Addendum #7

CONSIDER IN YOUR RESPONSE/BID THE FOLLOWING ITEMS OF ADDITION, DELETION OR CLARIFICATION. INDICATE IN THE SPACE PROVIDED ON THE RESPONSE/BID FORM THAT YOU HAVE RECEIVED AND INCLUDED FOR THE REQUIREMENTS OF THIS ADDENDUM. SICKKIDS MAY, IN ITS SOLE DISCRETION ANSWER SIMILAR QUESTIONS FROM VARIOUS RESPONDENTS ONLY ONCE.

RE: QUESTIONS AND ANSWERS, SPECIFICATIONS, DRAWINGS AND DOCUMENTS

Drawing No.	MA 02 EW 01

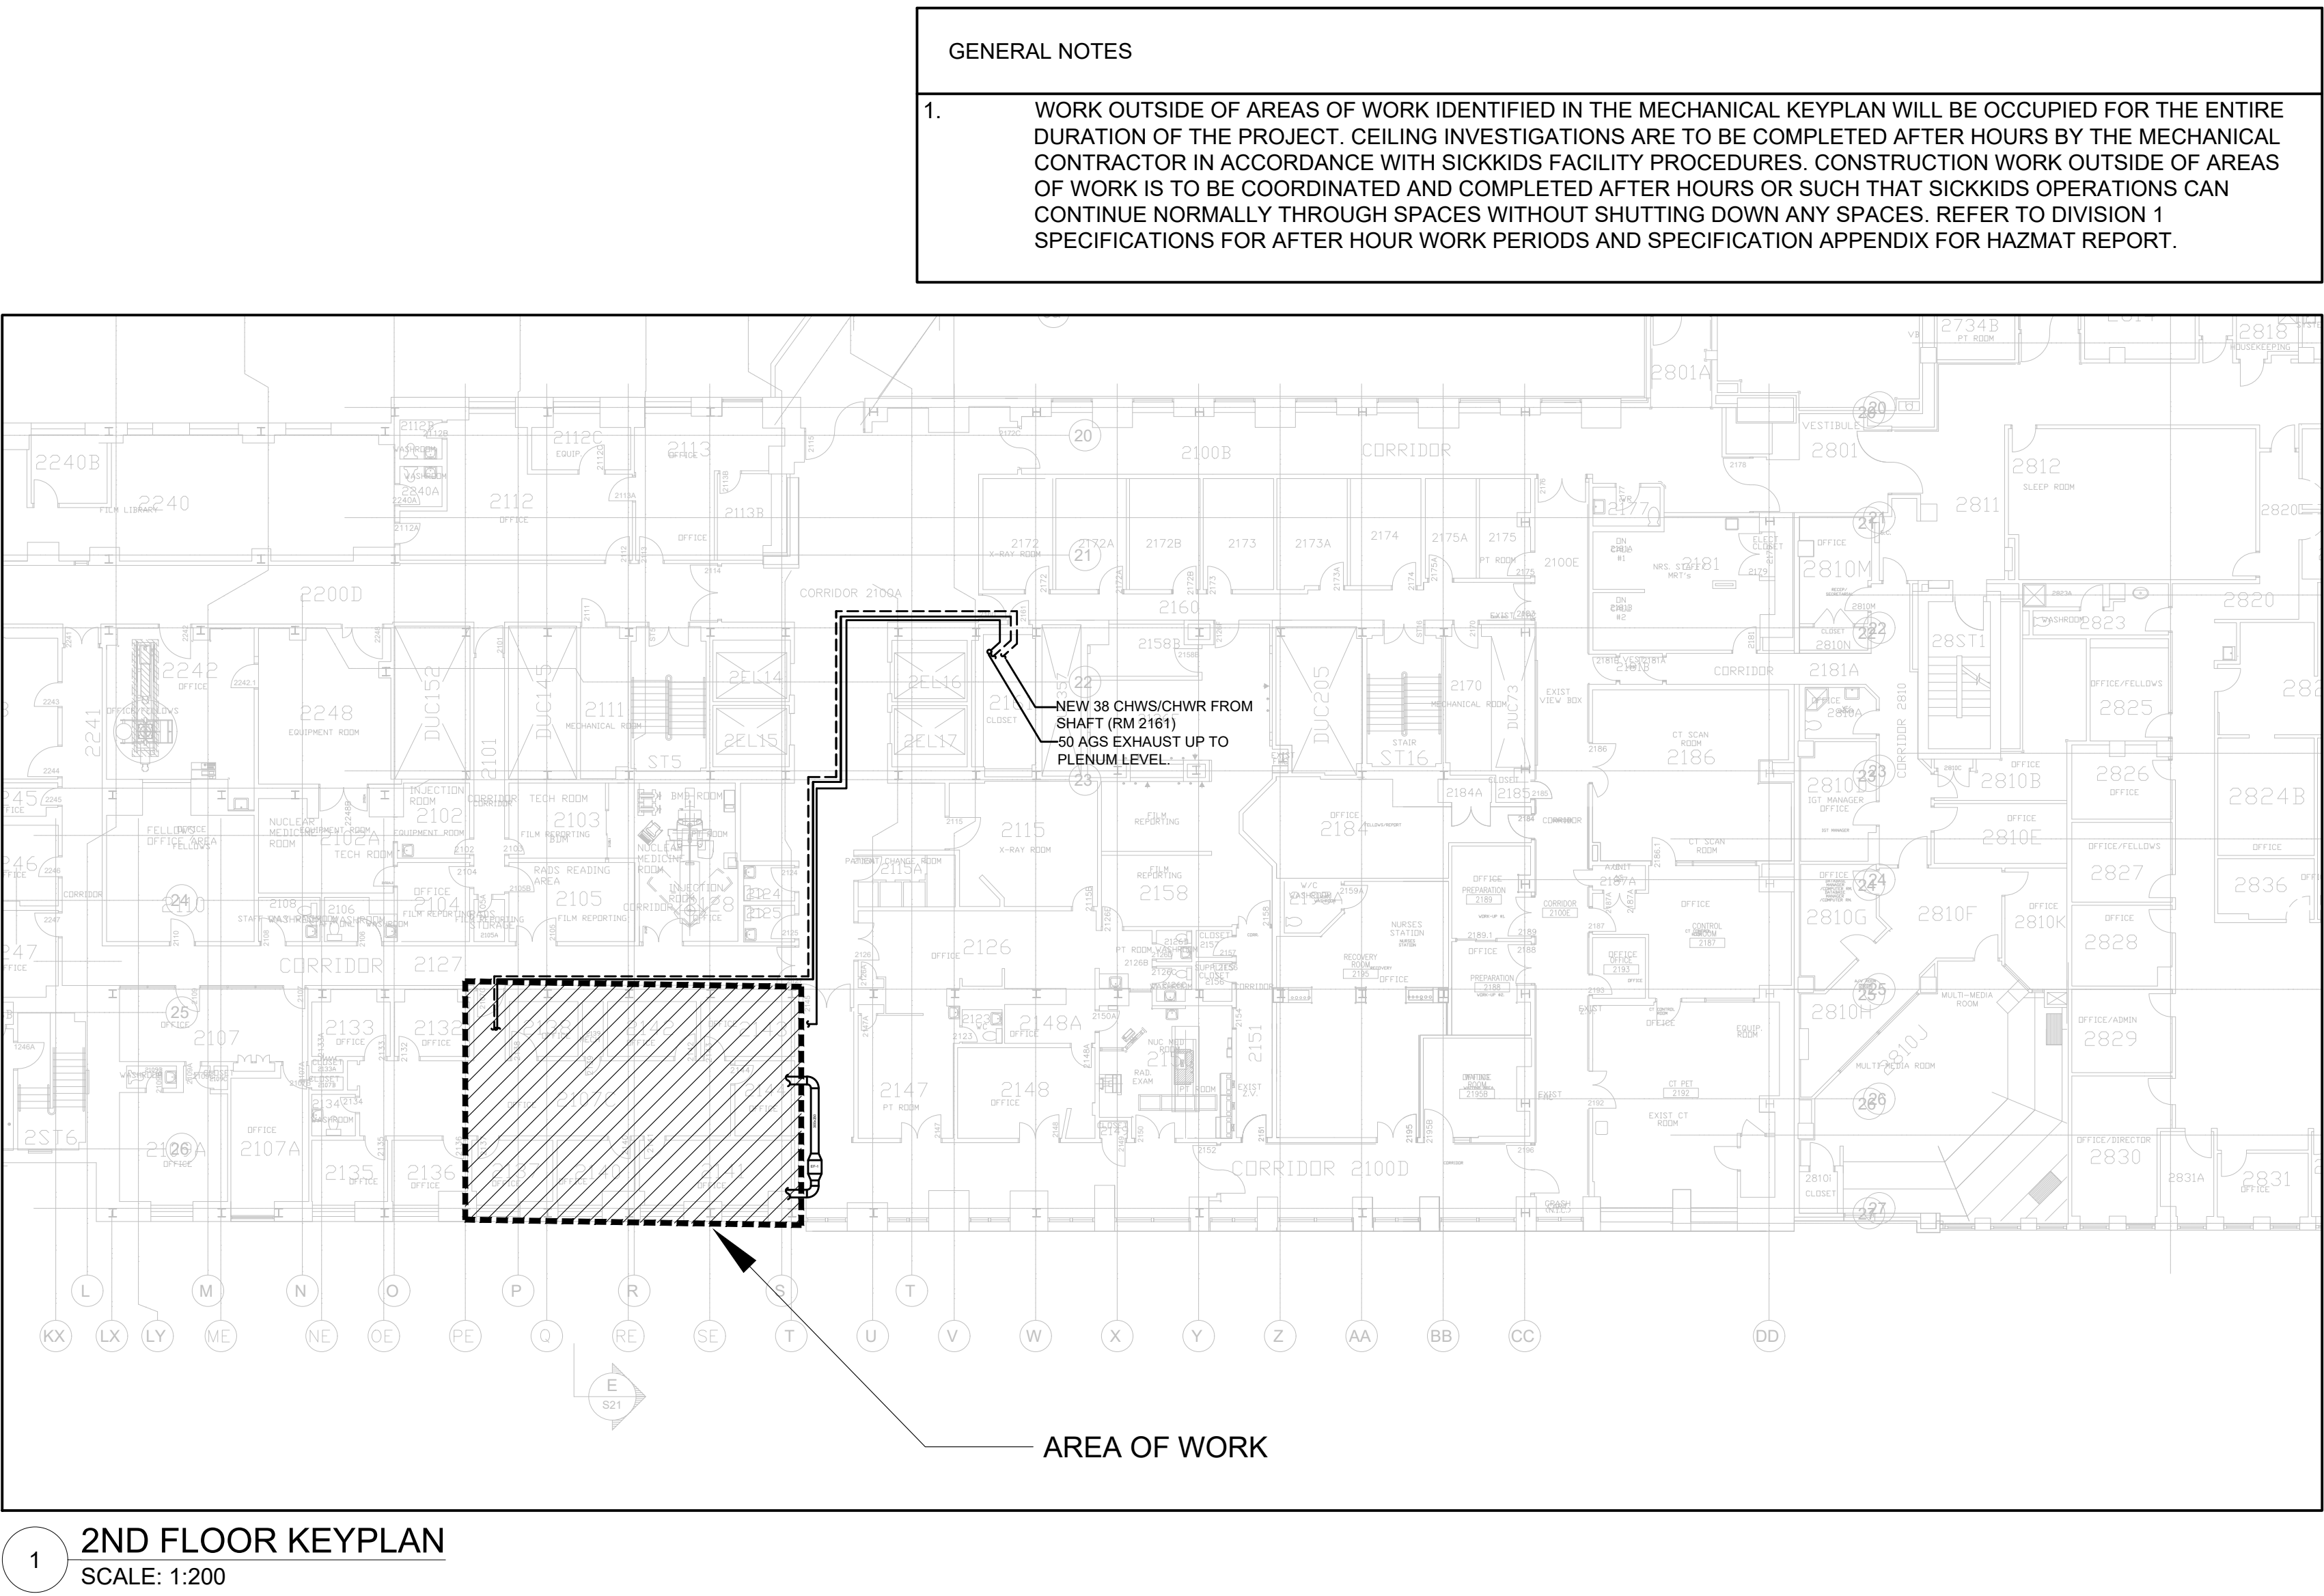
1. **Drawing MA 02 EW 01 – MECHANICAL DRAWING LIST, SYMBOL LIST AND KEYPLAN.**
 - Revisions to drawing list.
2. **Drawing MP 01 EW 01 – LEVEL 1 PART PLANS – PLUMBING – DEMOLITION AND NEW WORK.**

Drawing No.
MP 01 EW 01

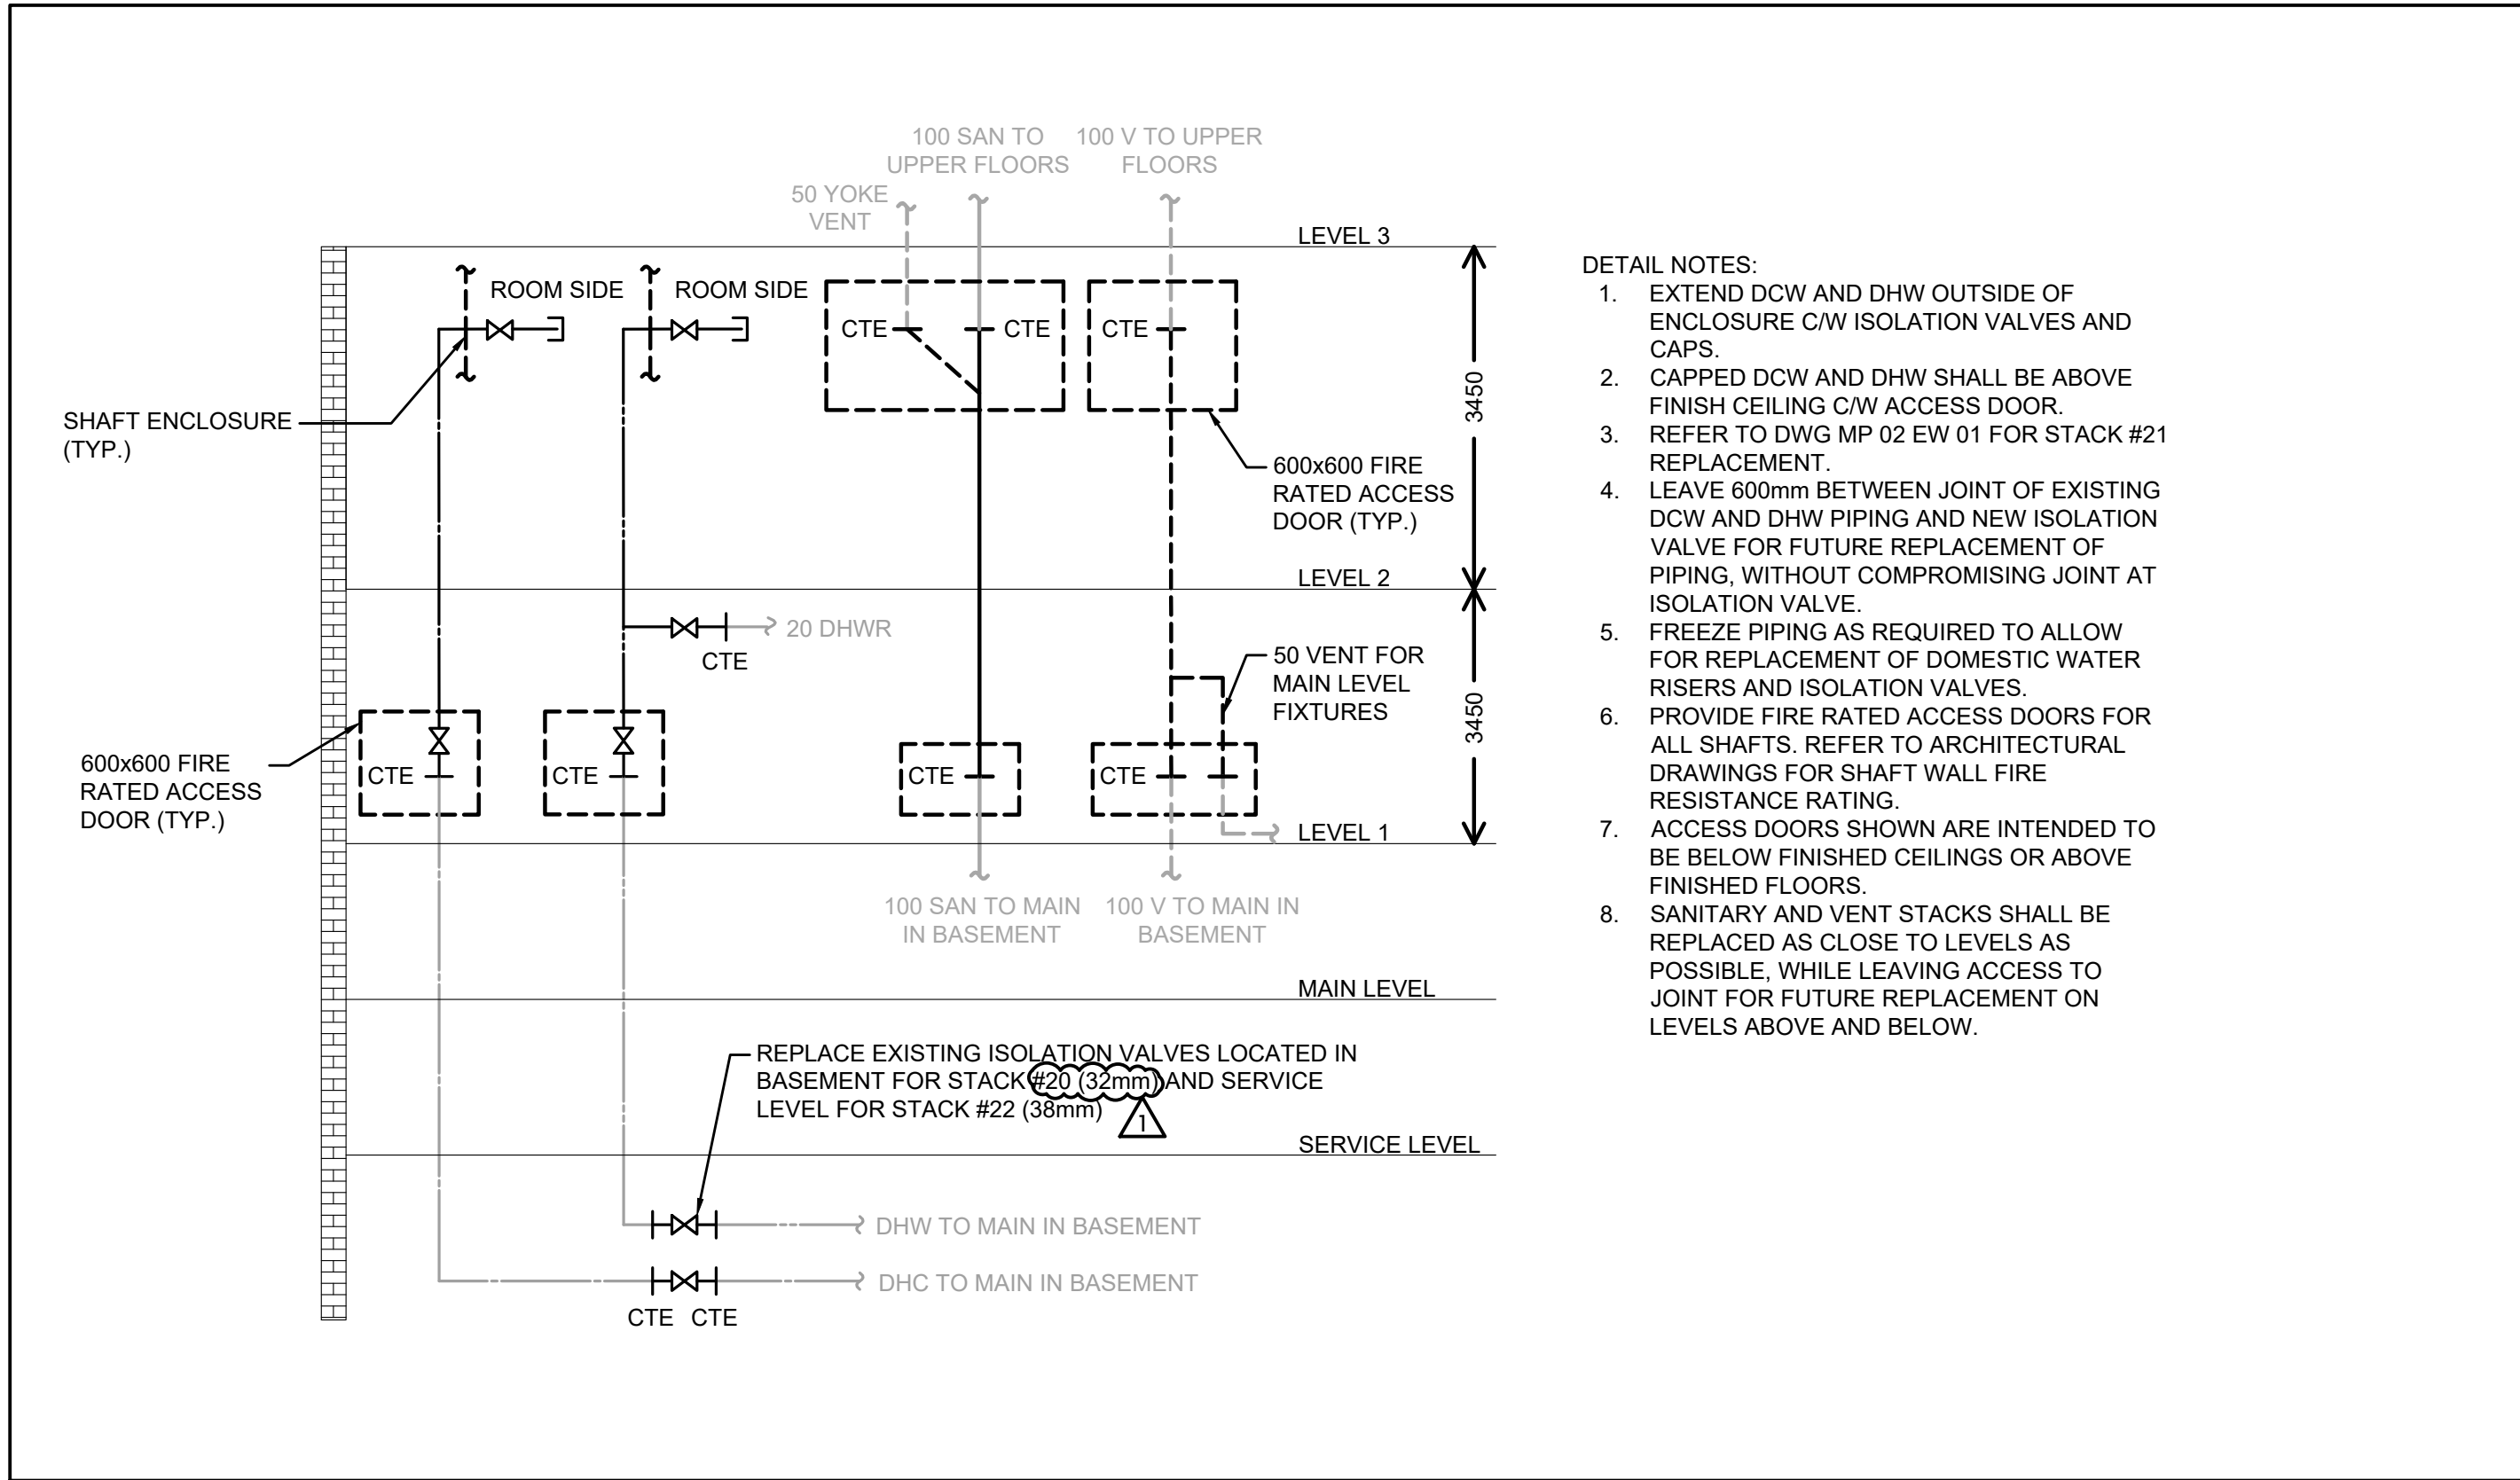
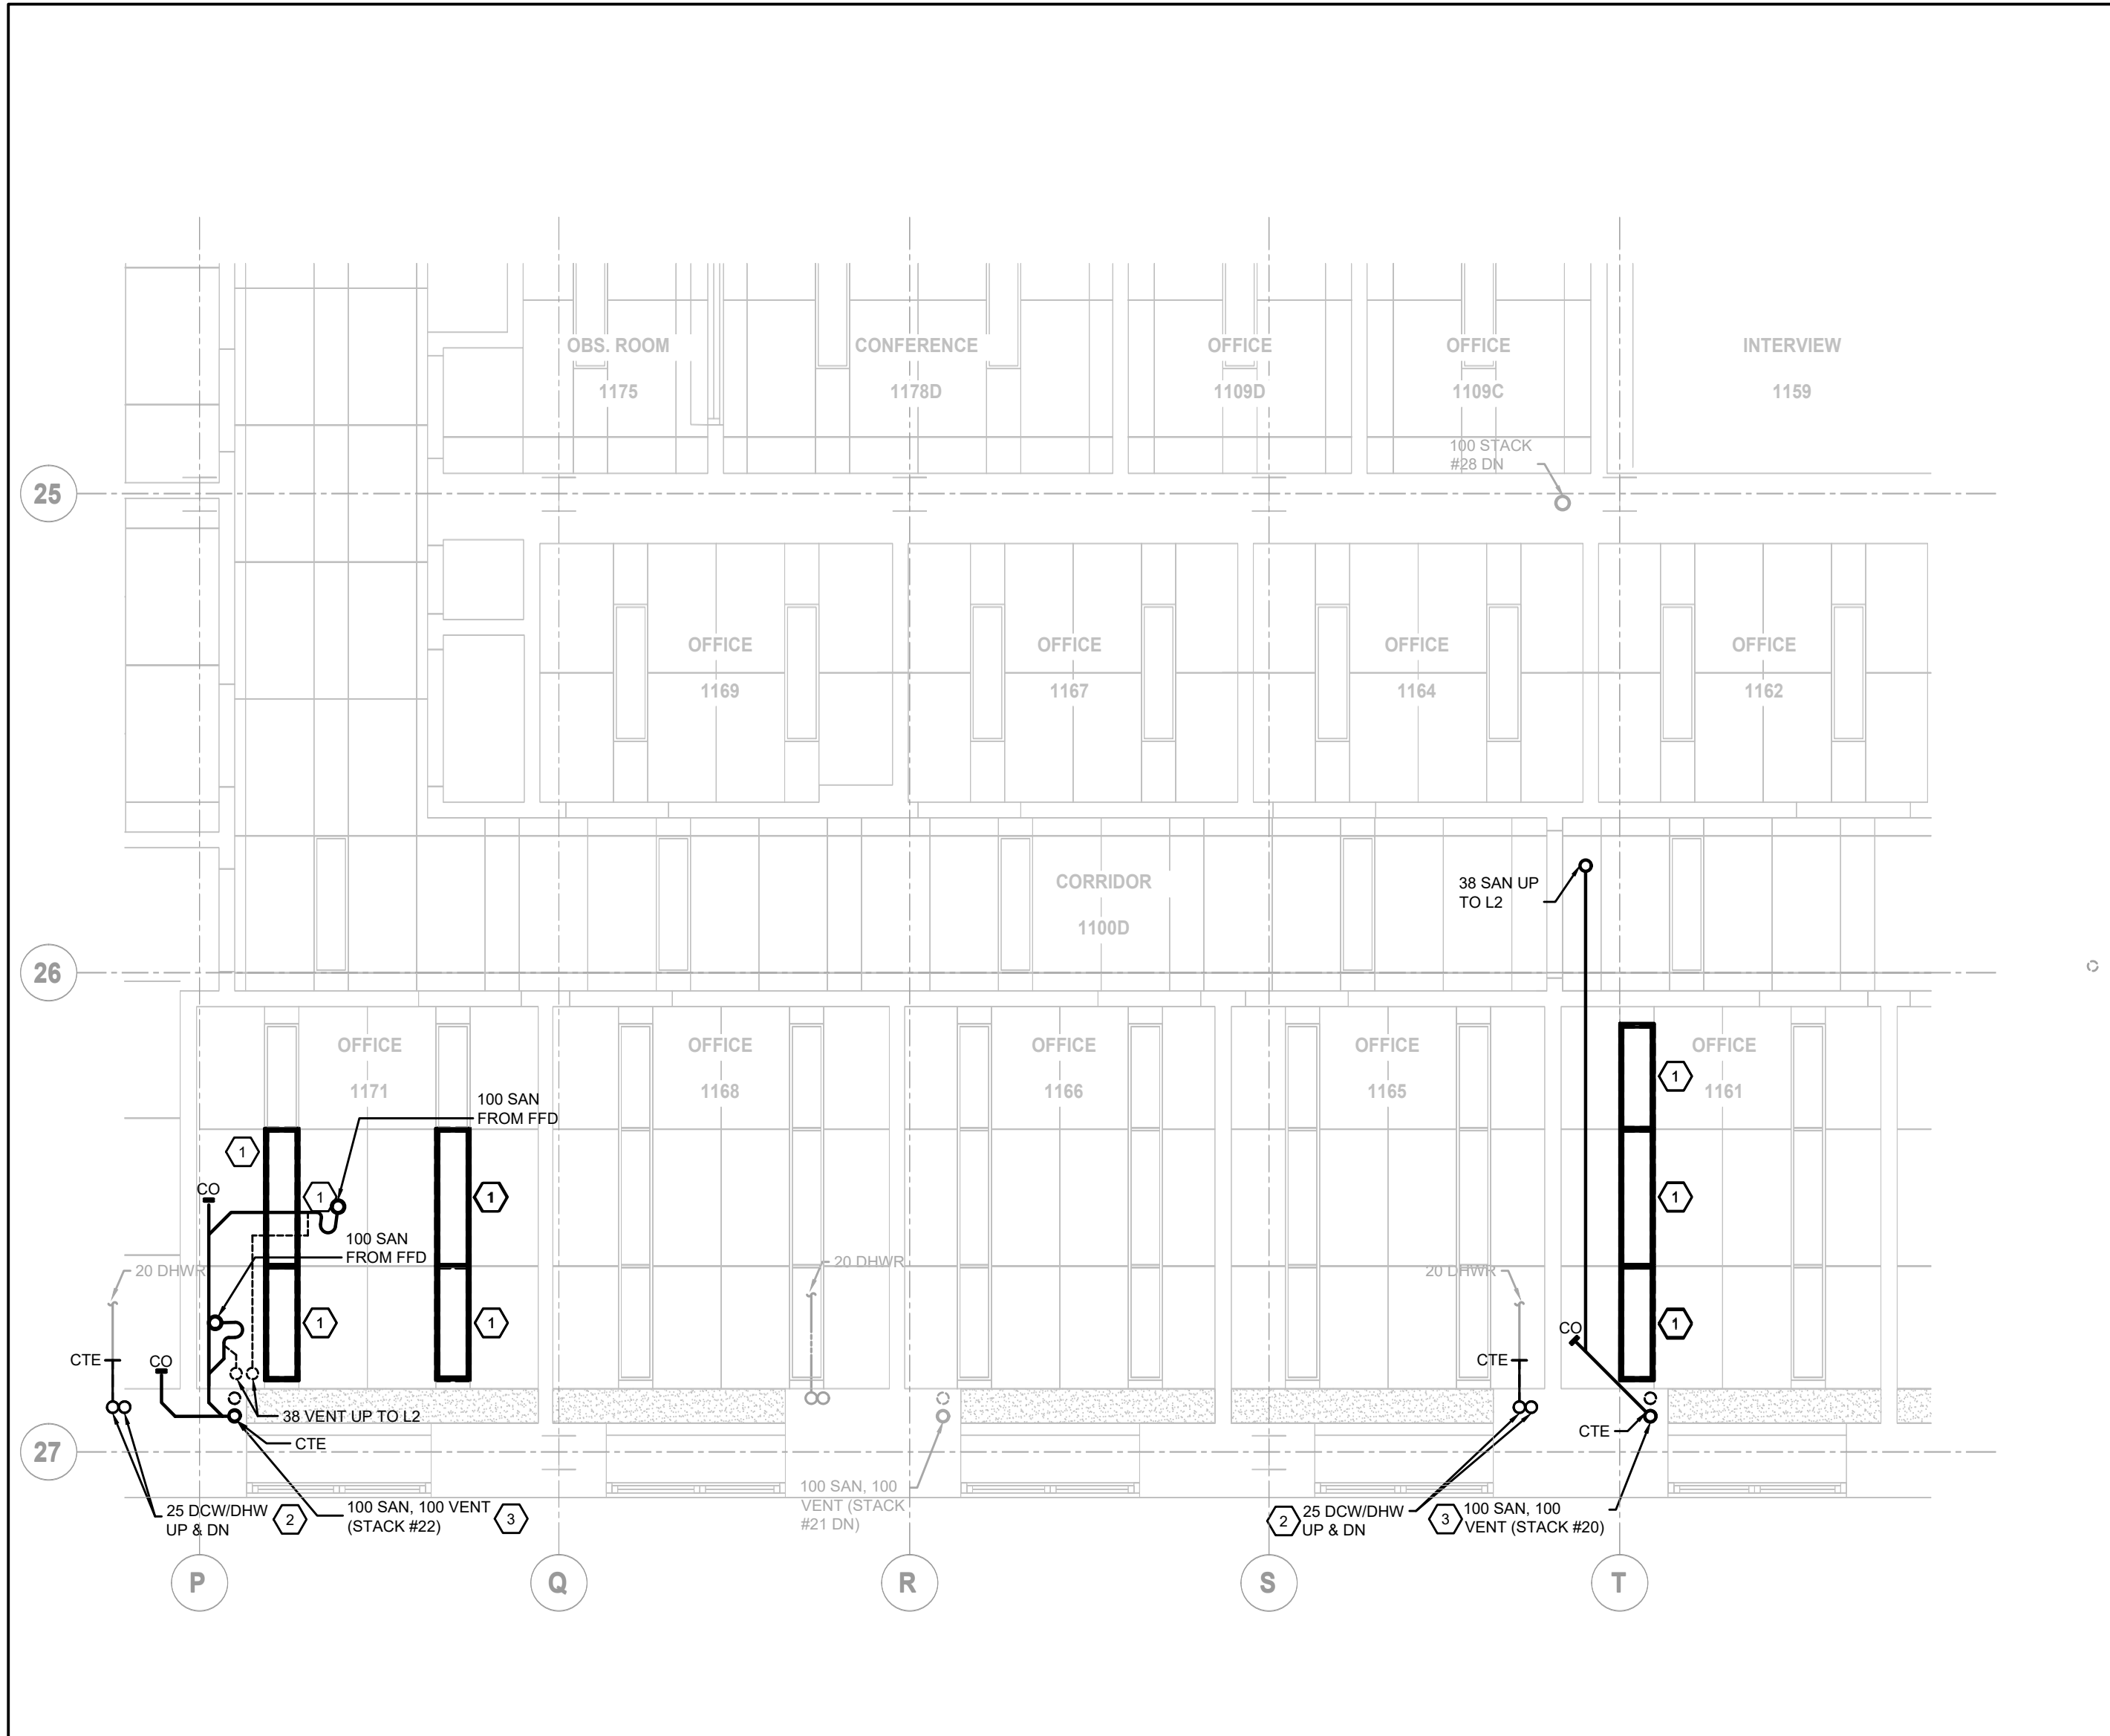
- Revisions to domestic water pipe size.
3. **Drawing MP 02 EW 01 – LEVEL 2 PART PLANS – PLUMBING – DEMOLITION AND NEW WORK.**
 - Revisions to drawing sheet keynotes.
